STATE OF TENNESSEE
DEPARTMENT OF TRANSPORTATION
DESIGN DIVISION
NASHVILLE, TENNESSEE 37243-0348

INSTRUCTIONAL BULLETIN NO. 11-21

Regarding Revised Standard Drawings

Effective for the March 23, 2012 letting, the revised Standard Drawings are to be printed with the plans. These drawings shall be identified on the lower left side of the index sheet **"To be printed with plans"** until the drawings are formally distributed.

CONNECTION DETAIL FOR PERFORATED/KNOCKOUT SQUARE TUBE POST

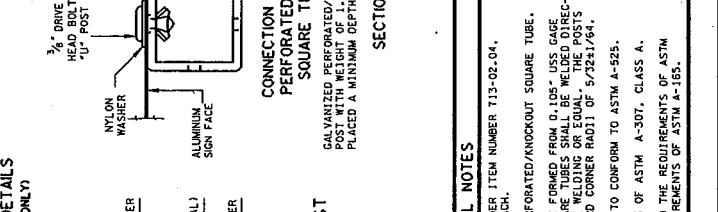
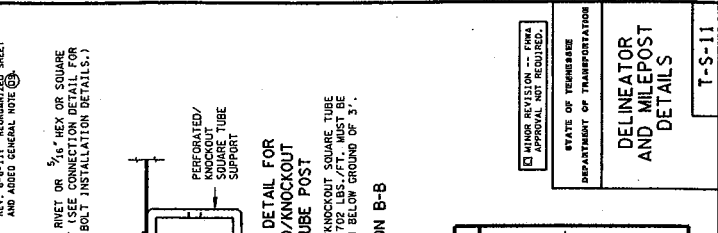
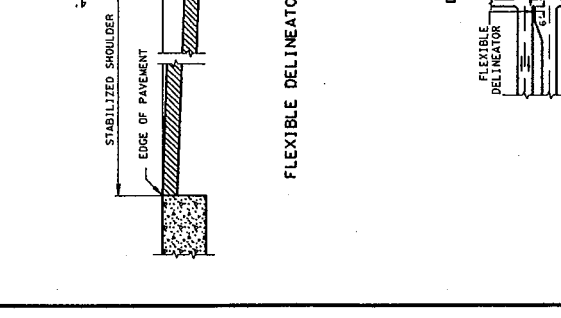
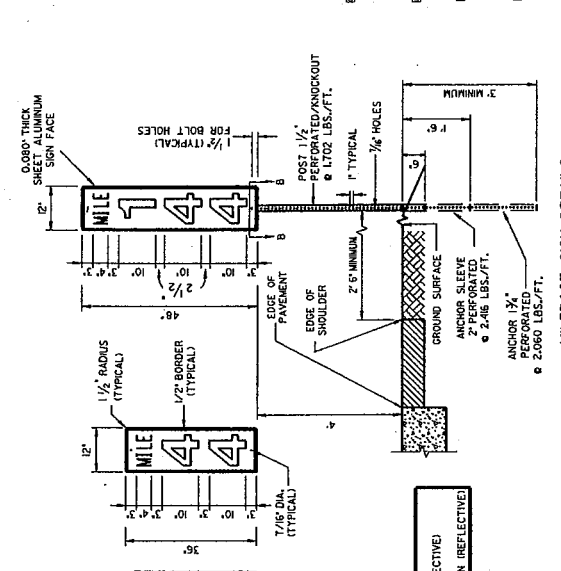
REV. 6-6-11: REORGANIZED SHEET AND ADDED GENERAL NOTE ③.
